# 1946 SPRING SERVICE MAILING PIECE

## FLOOR SIDE SILL PANELS

1951 and 20th Series Clipper

Section of 21st Series weatherstrip cemented to door hinge pillar on 20th Series car.

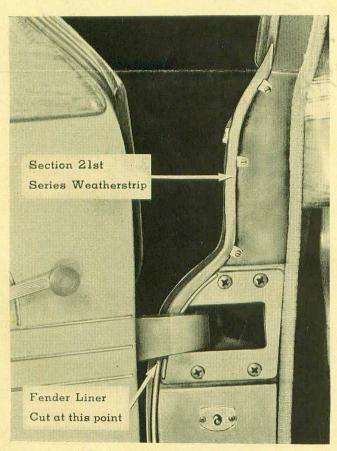
Rust conditions have been encountered at the floor side sill panels. When this condition exists to the extent that side sill repairs are necessary, all possible precautions should be taken to prevent a recurrence of this condition.

The side sills are continuously subjected to moisture and the source of the water and the suggested corrective measures are as follows:

1. Water is admitted at the rear side of the front door body pillar at the belt moulding, runs down the face of the pillar and travels back along the scuff plate. It then runs outward under the scuff plate and between the side sill and rubber mat.

To prevent water from entering at the front body pillar a section of the front fender to body liner is removed. This is replaced by a section of the 21st Series weatherstrip, piece number 385082—right, and piece number 385083—left.

Approximately ½ inch of the fender liner extends beyond the rear edge of the

fender. Cut the liner along the edge of the fender down to a point opposite the lower edge of the door upper hinge. The upper section of the new weatherstrip is then cut off and should be cut so that, when installed, the lower end will meet the fender liner at the point opposite the door hinge and the upper end should extend approximately 1 inch above the end of the drain gutter.

The section of the weatherstrip which is normally between the fender and body is also cut off along the step or shoulder on the back of the weatherstrip. The curved section is then cemented to the pillar and the three tabs are secured to the face of the pillar with metal screws, piece number 8077.

# THE NEW WATER PUMP SEAL ALL MODELS

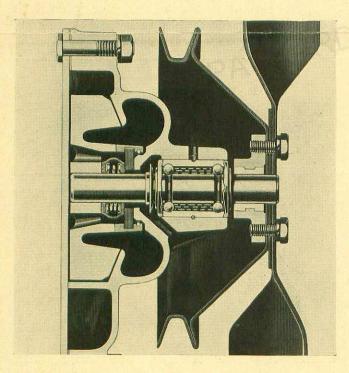
The water pumps used on 21st Series cars have been improved by use of a newly designed seal shown in the accompanying illustration. This new seal is interchangeable with the old and is now being shipped on service orders for all previous models.

The rubber packing and spring guide assembly (356479) and the spring (351548) have been replaced by a seal assembly (384890). In this design the seal spring is inside the rubber seal and holds the seal in contact with the impeller at one end and the thrust washer at the other end. Note that the seal does not contact the shaft.

The impregnated fiber seal thrust washer (351549) formerly used has been replaced by a compounded graphite type, (384891).

When installing the new seal assembly, thoroughly clean any accumulation of rust and scale from the face of the impeller against which the seal rests to provide a smooth even seat.

The new seal spring has less effective length than the old and it is important when refacing the thrust face of the pump body not to remove any more metal than necessary. If too much stock is removed, the spring will not have enough pressure to seal securely and the entire housing will have to be replaced.
